**STATE SIGNIFICANT DEVELOPMENT
ASSESSMENT REPORT:**

***Sydney International Convention, Exhibition and
Entertainment Precinct (SICEEP), Darling Square
(formally The Haymarket), South East Plot, Darling
Harbour***

SSD 6633

Environmental Assessment Report
Section 89H of the *Environmental Planning and
Assessment Act 1979*

Figure 8: Stage 1 Concept Approval maximum SE Plot building envelope (red) and the proposed development (Source: Applicant's EIS)

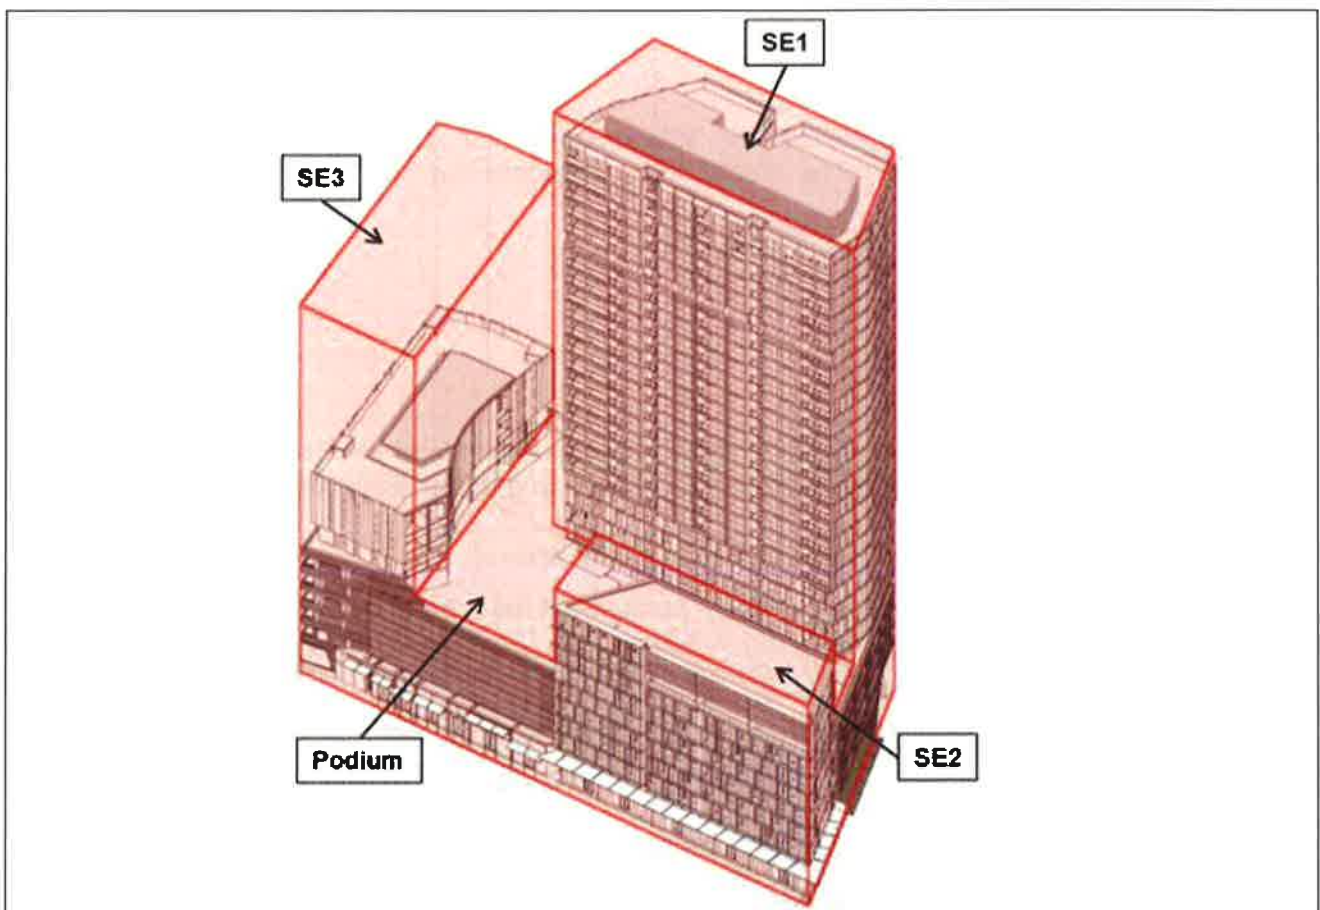
Council has raised concern that as the approved building envelopes for the SE Plot (and across the Darling Square precinct) are larger than the proposed buildings, there may be an expectation that these volumes be developed at a later stage via a modification application.

The Department considers the proposed development fully complies with the Stage 1 Concept Approval parameters as outlined in **Table 8** and **Figure 8**. In addition, the Department notes the proposed lower height of the SE3 tower, when compared to the Stage 1 Concept Approval maximum building envelope, results in positive improvements to view sharing and solar access with the nearby residential apartments, including The Peak Apartments, and overshadowing of public domain.

Figure 9: The original ground floor level undercroft layout and elevation including the location of proposed uses and inactive areas, additional windows inserted by applicant outlined in green (Base source: Applicant's RtS)

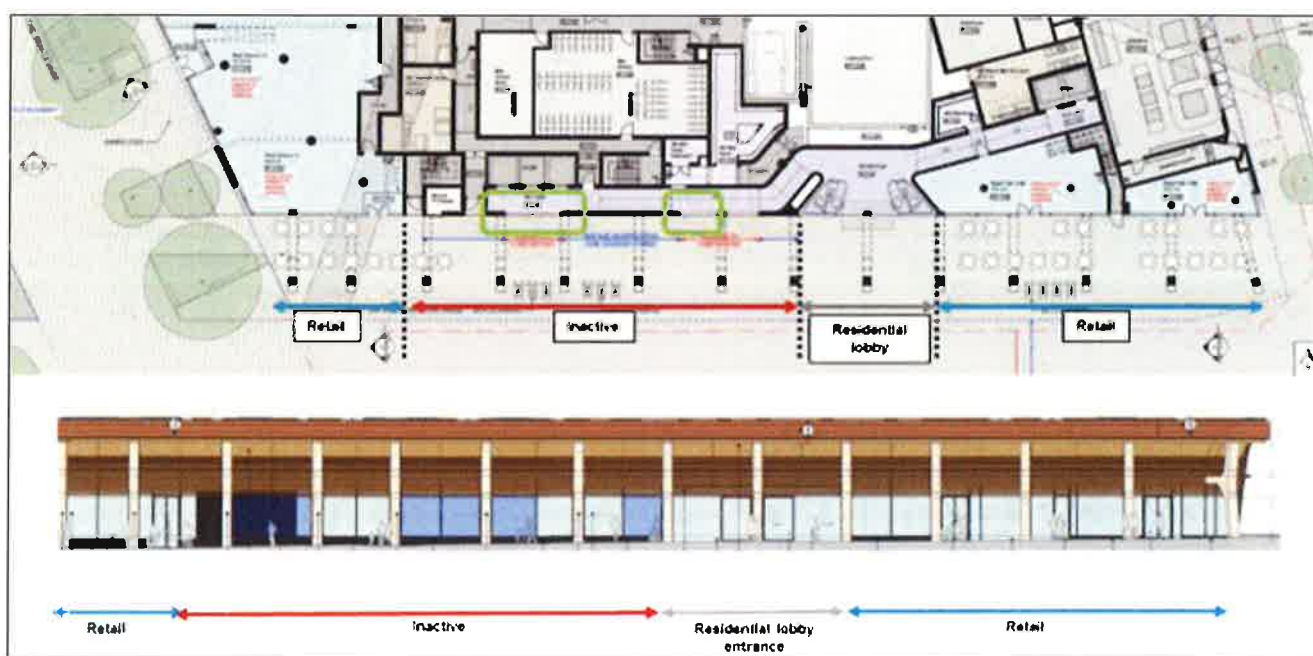
The Department raised concern that a continuous length of 35 metres (41%) of the undercroft elevation would not be activated and this portion of the elevation is centrally located within the undercroft. Further, the residential lobby provides some level of activation, however, this is considered less intensive than a retail frontage.

In response, the applicant has amended the proposal by separating the shared SE1/SE3 residential lobby into two separate lobbies and included a large retail unit between the two lobbies as shown at **Figure 10**.

Figure 10: The amended ground floor level undercroft layout and elevation including the location of proposed uses and inactive areas (Base source: Applicant's Addendum).

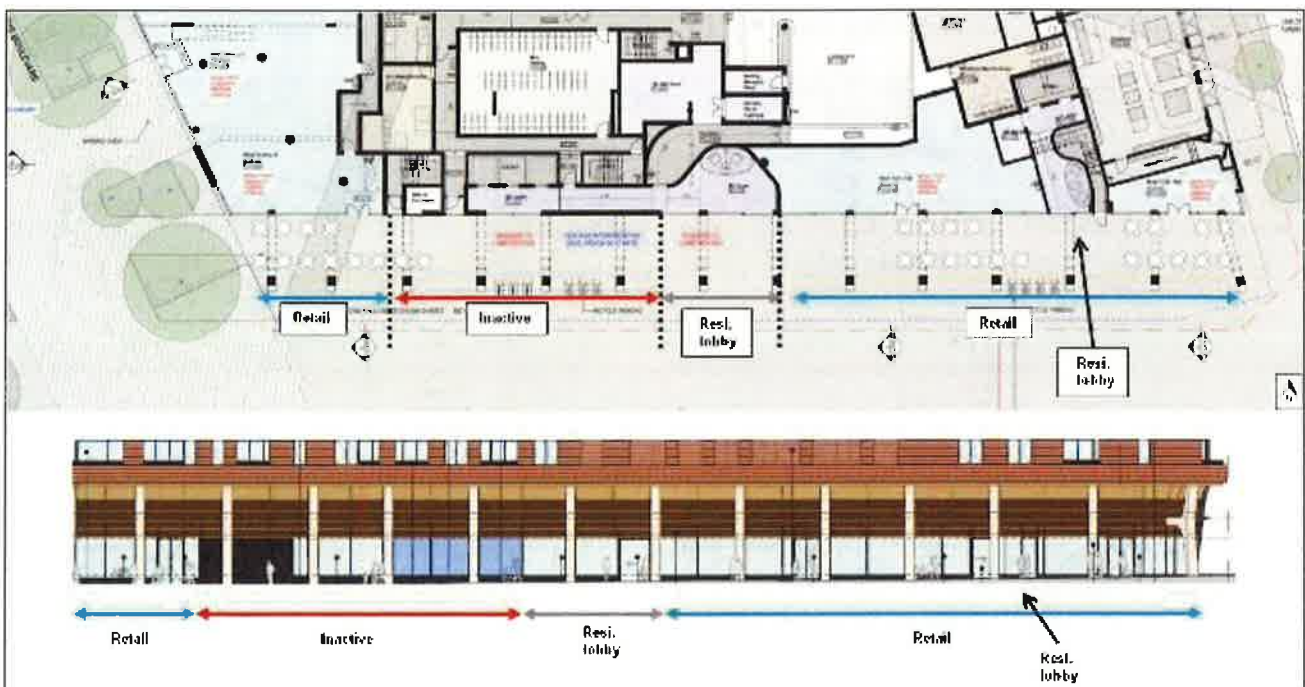
The Department notes the revised proposal has increased the width/frontage of retail units by approximately 12 metres (now occupying 60% of the total facade), increased the size of retail accommodation by 67 m² and created two residential lobbies with reduced internal corridor lengths.

In light of the above amendments, the undercroft elevation is now divided as described below (and shown at **Figure 10**):

- 51 metres (59%) of active glazed retail tenancy frontages;
- 10 metres (12%) of glazed lobby entrance; and
- 25 metres (29%) of blank wall / heritage interpretation and corridor windows.

The Department is satisfied the proposal has adequately responded to the concerns raised and will provide an appropriate level of activation within the undercroft area and internal residential amenity.

Figure 12: Solar access to the SE Plot, generally unobstructed solar access shown in yellow (Base source: applicant's EIS)

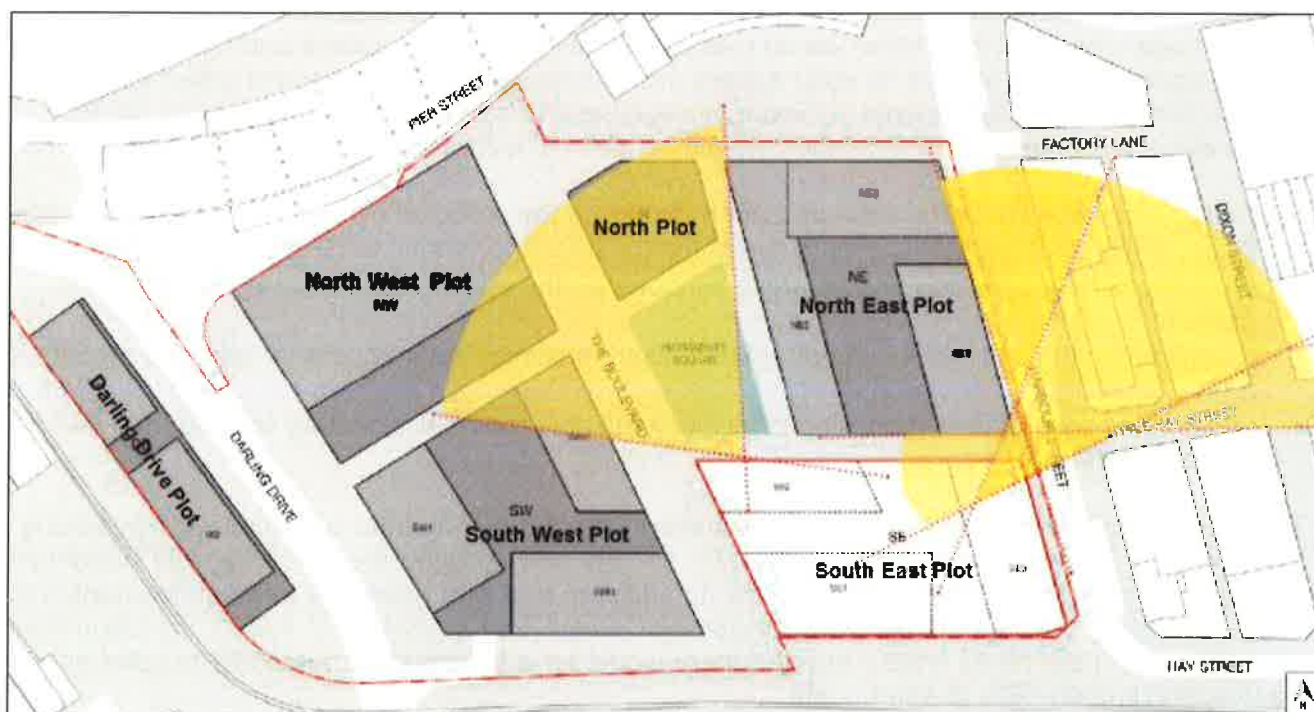
As originally submitted, the proposal did not meet the ADG's solar access recommendations as 183 of 391 apartments (47%) achieved two hours of sunlight and 34% of apartments received no solar access between the hours of 9am and 3pm midwinter.

The Department notes that achieving the ADG recommended level of solar access is difficult on the SE Plot for the following reasons (refer to **Figure 12**):

In response to these concerns, the applicant has revised the proposal by:

Figure 15: Building separation between the South East Plot and North East Plot buildings

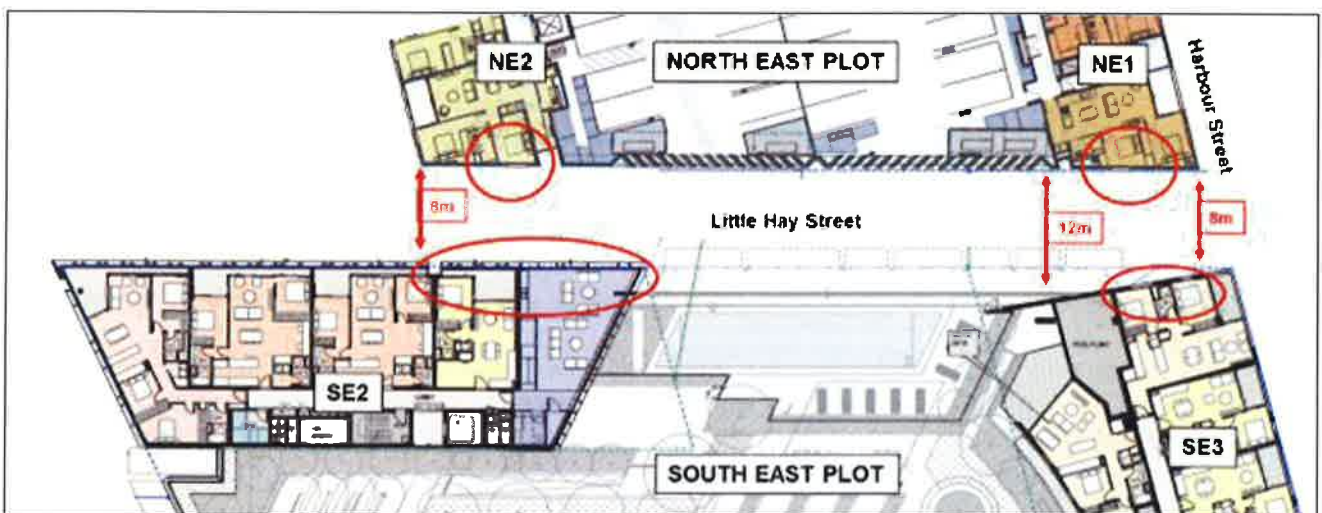
The Department is concerned the proposed internal layout would result in overlooking in the following locations (refer to **Figure 15**):

In response to the concerns raised, the applicant has confirmed that privacy screens or opaque glazing would be included to the bedroom windows of the affected apartments in the North East Plot development to the north (bedroom windows circled in red at **Figure 15**). The applicant has provided a letter of undertaking that the window treatments would be included as part of a forthcoming Section 96 modification application for the North East Plot.

To ensure an appropriate level of privacy is achieved, the Department recommends a condition that requires the windows of the apartments at each level be treated/screened to prevent direct overlooking, unless this has already been achieved via modification of the North East Plot development.
